Re: Water Use Permit Modification Application #931209-5
Southern State Utilities, Collier County, Florida

RE: Water Use Permit Modification Application #931209-5
Southern States Utilities, Collier County, FL

This correspondence is intended as the ViroGroup, Inc. (VGI) response to your letter of July 27, 1994 (copy attached) requesting additional information relative to the above-referenced permit application. A response is provided below to each of the four items requested. For staff convenience, SFWMD questions are restated in this letter.

FIGURE 1. SITE MAP SHOWING SPOIL REMOVAL AREA AND WELLFIELD CONFIGURATION.

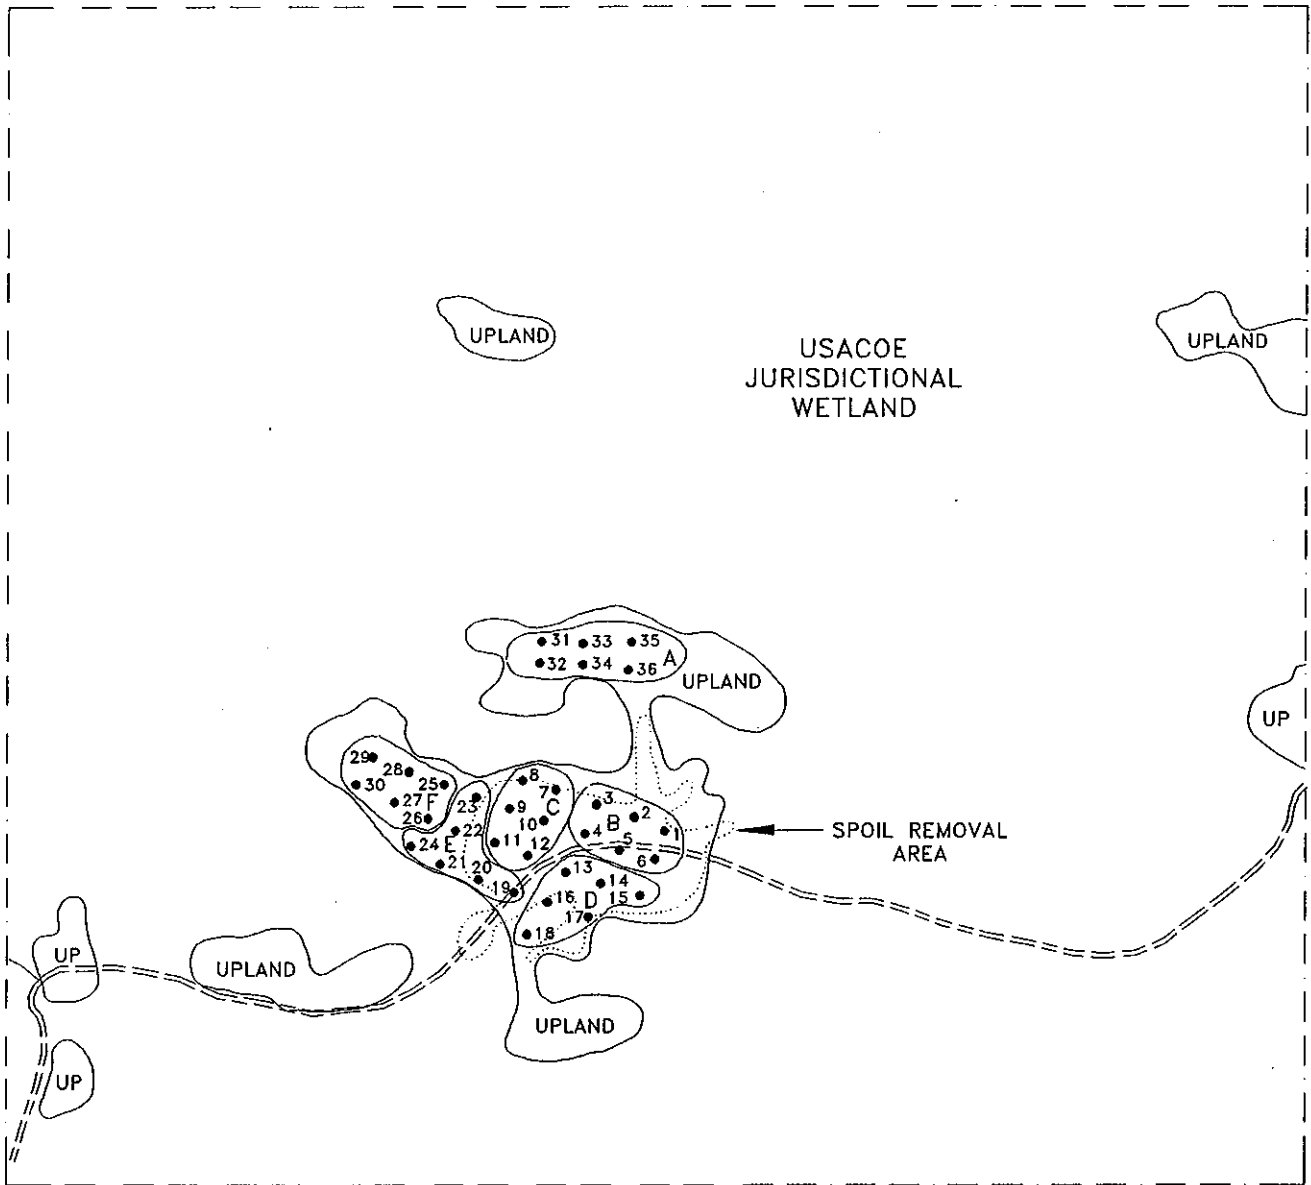
It will also be necessary for you to incorporate the design of the wellfield itself into the surface water management (C&O) permit application. District Staff has received a

copy of a letter to the applicant from the Army Corps of Engineers (ACOE) which indicates that the existing fill material on the wellfield site was placed in a wetland, and served violation notice with Cease and Desist Order 199403255 (C&D-SB). Consequently, the surface water management permit application will need to address the placement of well pads within areas which are considered to be wetlands. If you need further information regarding this matter, please contact Karen Johnson or Deborah Marzella at this office.

R1. It is our understanding that the surface water management application, which was originally submitted by Hartman & Associates for conceptual approval, will be revised in order to obtain construction and operations surface water management approval. The proposed wellfield location and design will be incorporated in the surface water management permit application.

Southern States Utilities (SSU) representatives, along with its consulting ecologist, Coast Plan, Inc., have met with representatives of the USACOE and resolved the issue of placement of lime sludge in on-site wetlands. It has been agreed that SSU will remove fill from the narrow, elongated area shown on Figure 1. As previously stated in other correspondence, the wellfield will be constructed on upland portions of the site, not in wetland areas.

R2. As described above, the Cease and Desist Order has been resolved to the effect that a small amount of fill will be removed from a narrow elongated wetland area. Jurisdictional boundaries, with this one minor exception, are as shown on previous submittals. Our response to Item 2, as provided in our July 1, 1994 letter (copy attached) is therefore still applicable.

FIGURE 4-1. HYDROSTRATIGRAPHIC COLUMN OF WELL CO-2305.

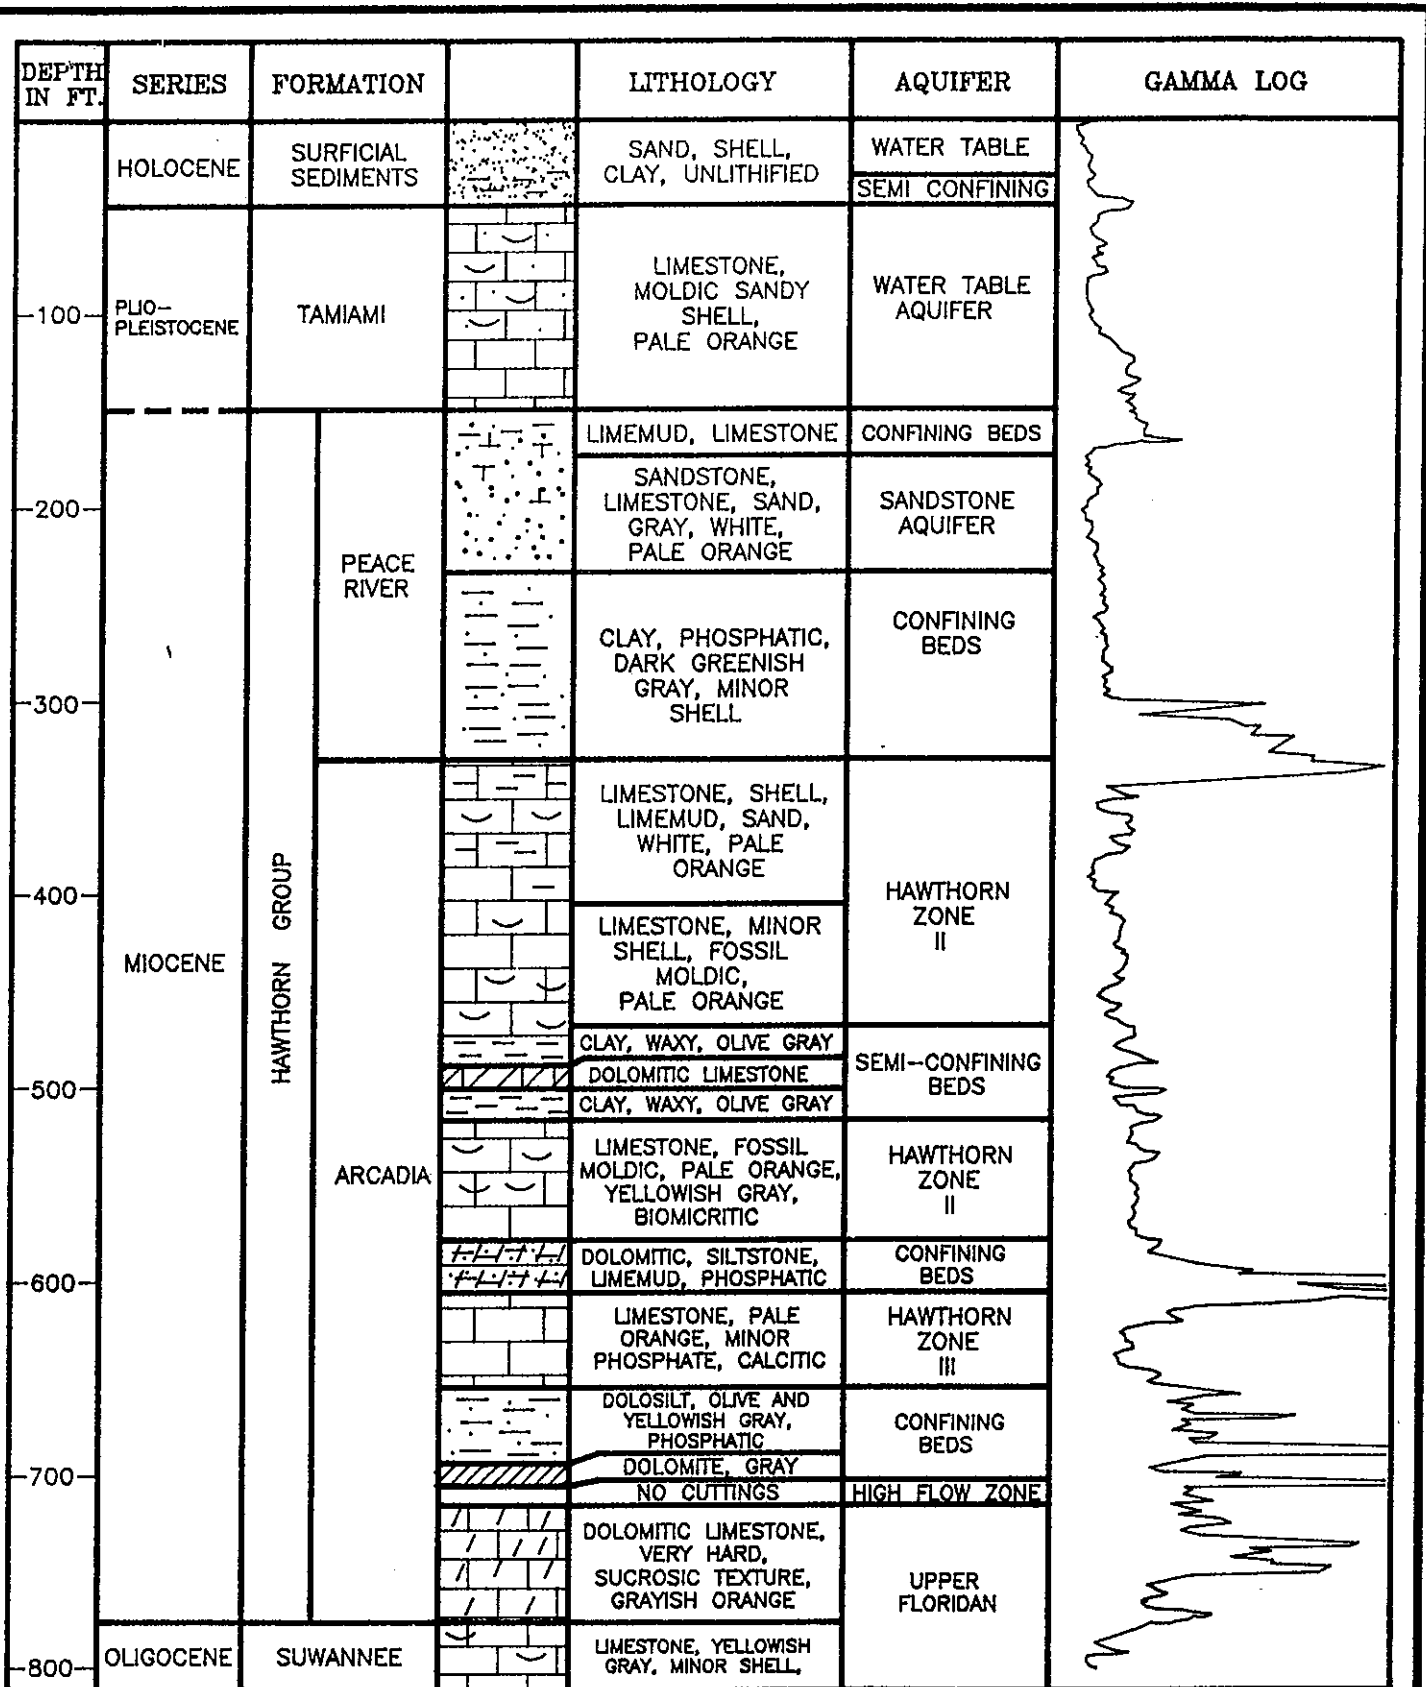
Regarding the model layering, does Layer 1 represent the Surficial Aquifer and Layer 2 represent the Lower Hawthorn aquifer? Please explain.

- R4. We would first like to clarify the hydrostratigraphic nomenclature used in reference to the Marco Island wellfield. In recent application materials we have requested the addition of five Lower Hawthorn Aquifer wells. Use of this nomenclature is not appropriate for the wellfield production zone. A more appropriate designation would be the Mid-Hawthorn Aquifer, because of the position of the production zone within the Hawthorn Group.

All of the current production wells are completed into what has been referred to as the Hawthorn Zone II, with casings set at approximately 400 feet below land surface. Attached find Figures 4-1 and 4-2 from the wellfield completion report illustrating the hydrostratigraphic relationships on Marco Island. We therefore request that the production zone be referred to as Mid-Hawthorn or Hawthorn Zone II in future correspondence. Also attached are previously submitted Figures 2, 3 and 4, with revised captions to reflect this nomenclature clarification.

Figure 2. Simulated drawdown in the Hawthorn Zone II resulting from withdrawal of 5.40 MGD (for 90 days) from existing wells.

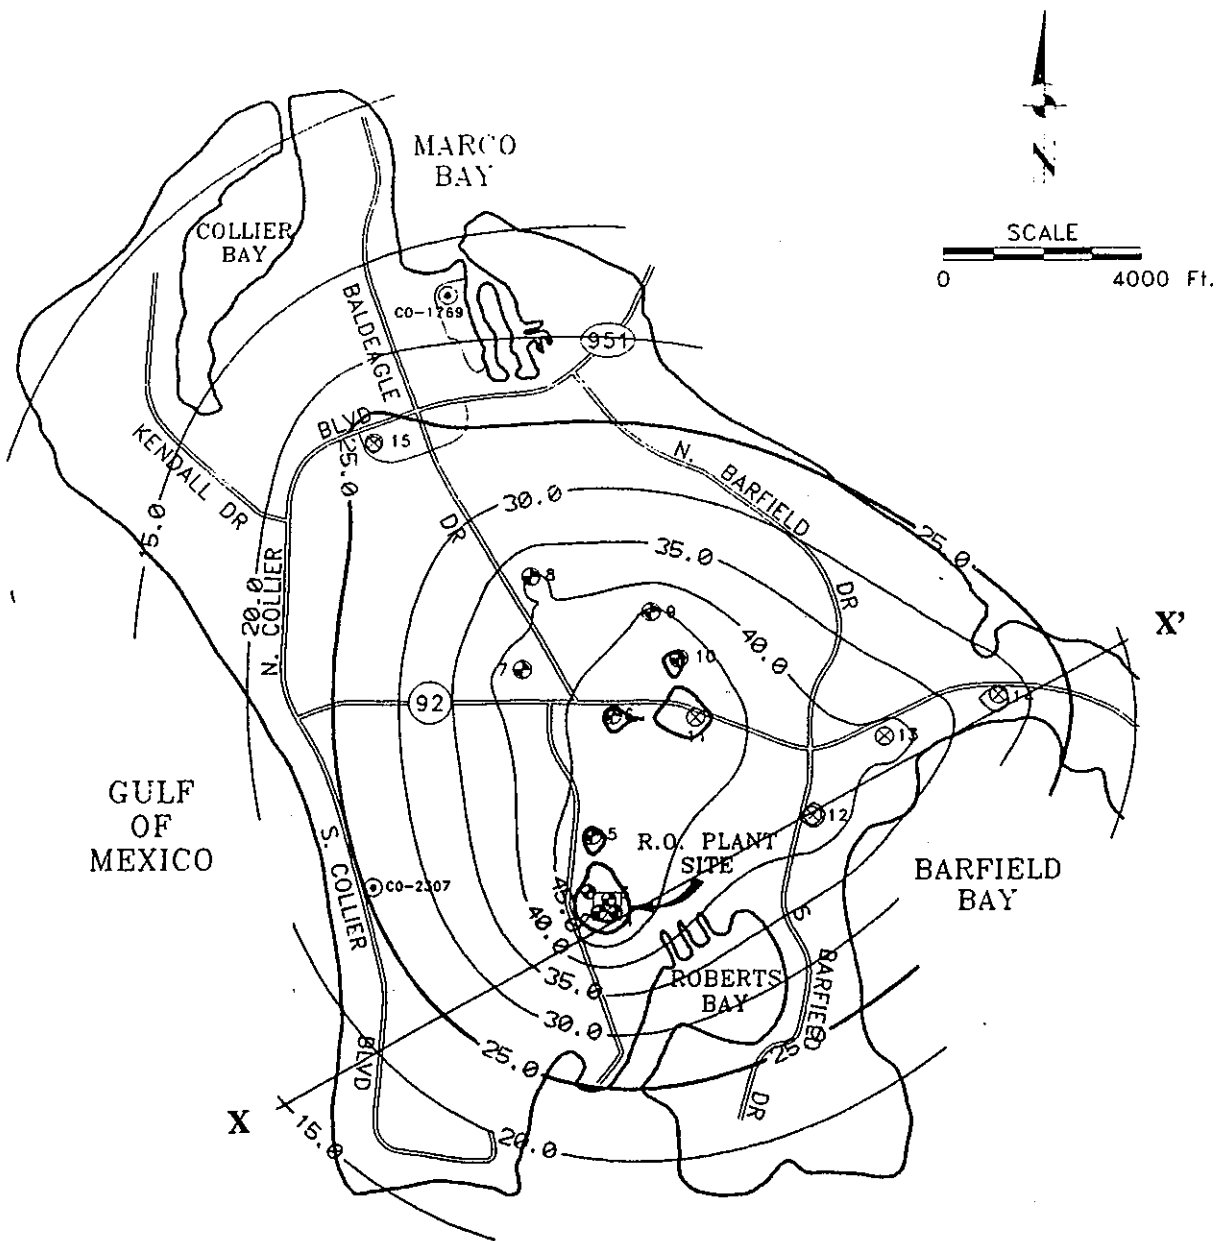
Q4. It was stated in your response that in addition to the modification requests included in the original submittal, five Lower Hawthorn aquifer wells are now being proposed for production from the wellfield on Marco Island. This request is considered a substantial modification to the original application as specified in Chapter 40E-1.603(8)(b), and is subject to the criteria for the conditions of permit issuance as specified in chapter 40E-2.301, FAC. Therefore, based upon this new information, please provide Staff with the projected cones of influence from the existing and proposed wellfield configurations ("before and after" contours) which provide reasonable assurance that the proposed withdrawals will meet criteria specified in section 3.4, BOR, and specifically Chapter 40E-2.301(1)(a) and it's consistency with Department of Environmental Protection (DEP) criteria specified in Chapter 17-520, FAC.

The simulated drawdown resulting from the currently permitted maximum day withdrawal of 5.4 MGD using the present wellfield configuration (Case I) is shown in Figure 2. The drawdown from the proposed wellfield configuration,
